APPLICATION NO.	FILING DATE	FIRST NAMED INVENTOR	ATTORNEY DOCKET NO.	CONFIRMATION NO.
10/779,290	02/13/2004	Hubert Beck	4452-592	7424

Office Action Summary

DETAILED ACTION

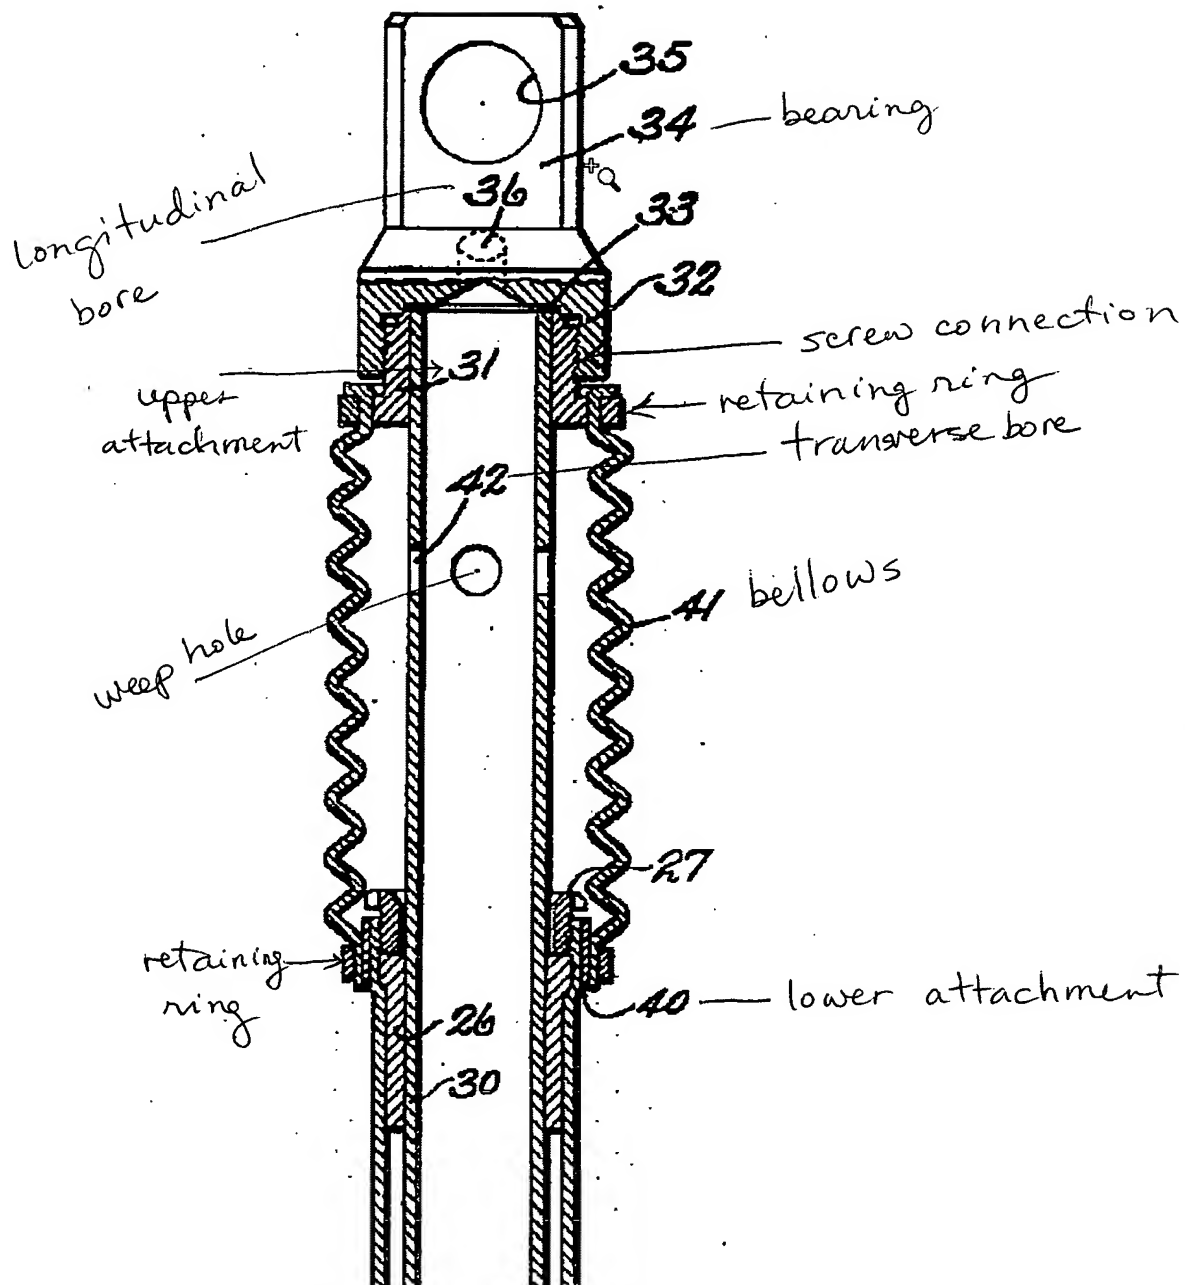
Re: claim 1, Funkhouser shows a piston-cylinder unit, as in the present invention, comprising a cylinder 20, a piston rod 50 having section projecting out of said cylinder as shown, said section having an end received through a mounting bearing 34 for connecting the piston-cylinder unit to a support not shown but mentioned as two relative moveable members in column 1, line 8, and a bellows 41 covering said section of said piston rod for protecting said section of said piston rod against at least one of dirt and damage, wherein an unimpeded flow connection 36, 42 is provided in the end of said piston rod, said flow connection being permanently open and communicating freely with an interior space defined in said bellows and freely with the atmosphere such that said flow connection allows a free flow of air between the atmosphere and said interior space when said interior space in said bellows undergoes a change in volume in response to a relative movement between the bearing and the cylinder, as stated in column 2, lines 10-12 and 23-28.

Re: claim 2, Funkhouser shows longitudinal bore 36 and transverse bore 42.

Re: claim 3, Funkhouser shows the mounting to be a screw joint as illustrated in figure 1.

Re: claim 10, Funkhouser further shows the bellows to be provided with a weep hole 42. Note that there are four holes 42.

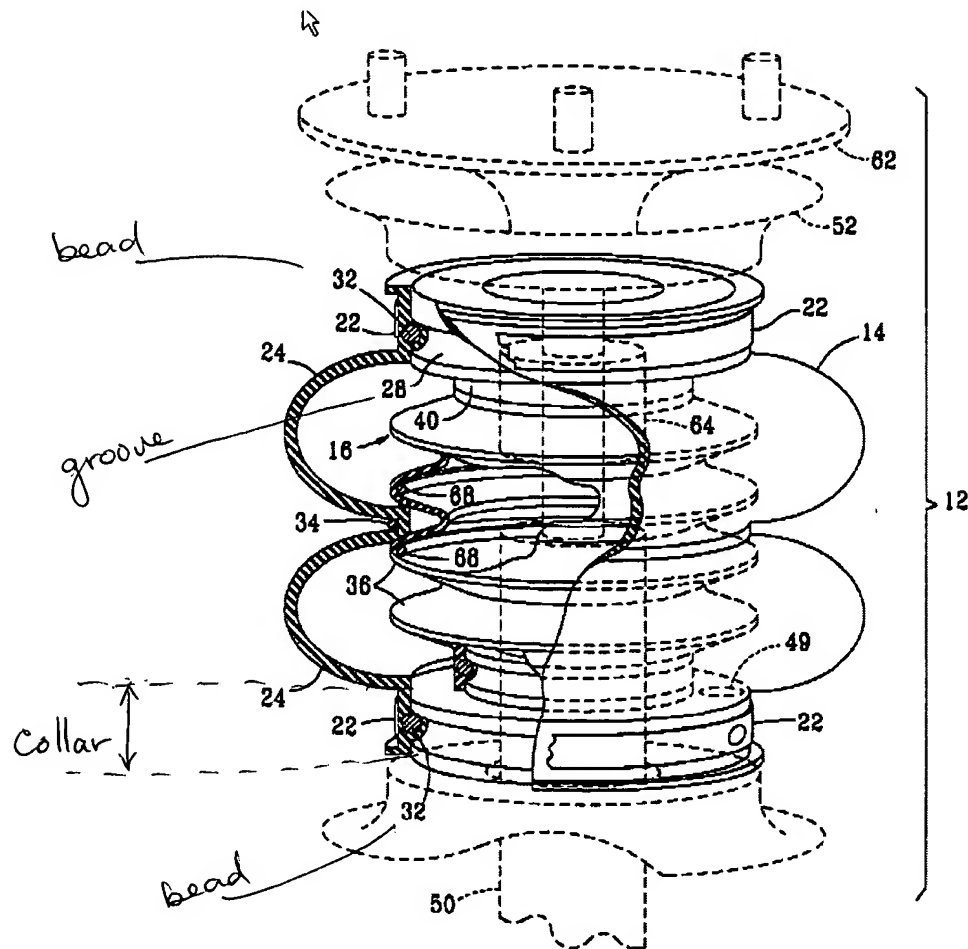
Re: claims 4 and 5, Funkhouser shows an upper attachment part 31 fixed to said bearing 34 and a retaining ring attaching the bellows to the upper attachment part 31, but lacks a groove and a bead from the bellows to engage the groove. Oishi teaches the concept of a groove 28 and a bead 32 to engage the groove in figure 2 below. It would have been obvious to one of ordinary skill in the art at the time the invention was made to have modified Funkhouser's unit to employ the bead and groove attachment arrangement as taught by Oishi to provide a secure connection with less number of parts as taught by Oishi. Furthermore, it is well settled that making one piece of the upper attachment part and the bearing to be old and well known knowledge.

Re: claim 11, Funkhouser shows an lower attachment part 40 and a retaining ring attaching the bellows to the lower attachment part, but lacks a groove and a bead from the bellows to engage the groove. Oishi teaches the concept of a groove 28 and a bead 32 to engage the groove in figure 2 below. It would have been obvious to one of ordinary skill in the art at the time the invention was made to have modified Funkhouser's unit to employ the bead and groove attachment arrangement as taught by Oishi to provide a secure connection with less number of parts as taught by Oishi.

Re: claim 12, Oishi further teaches a collar as marked above. As modified, said collar would be loaded axially against the cylinder of Funkhouser.
